SUPPLEMENT TO CB750K1~K4

COMPARISON OF CB750K2 TO CB750K1

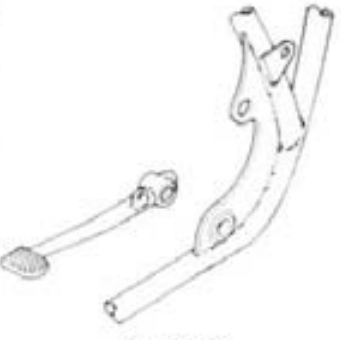
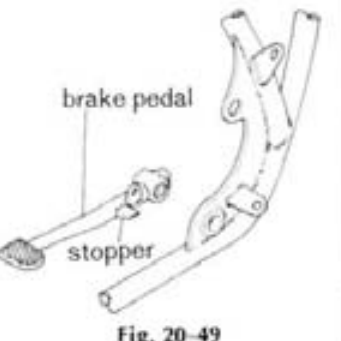
Part of item	CB 750 K1	CB 750 K2	Modified part
seat seat catch seat lock	 <p>Fig. 20-46</p>	 <p>Seat catch</p> <p>Service book bag</p> <p>Fig. 20-47</p> <p>The seat was changed in pattern and partially in shape. The seat catch was changed as down.</p>	seat catch seat lock
brake pedal	 <p>Fig. 20-48</p>	 <p>brake pedal</p> <p>stopper</p> <p>Fig. 20-49</p> <p>A stop was added to the brake pedal, returning the pedal properly.</p>	
driven flange	 <p>fixing bolt</p> <p>driven flange</p> <p>Fig. 20-50</p>	 <p>driven flange</p> <p>stad bolt</p> <p>Fig. 20-51</p> <p>The fixing bolt was changed from the removable type to the press-in type.</p>
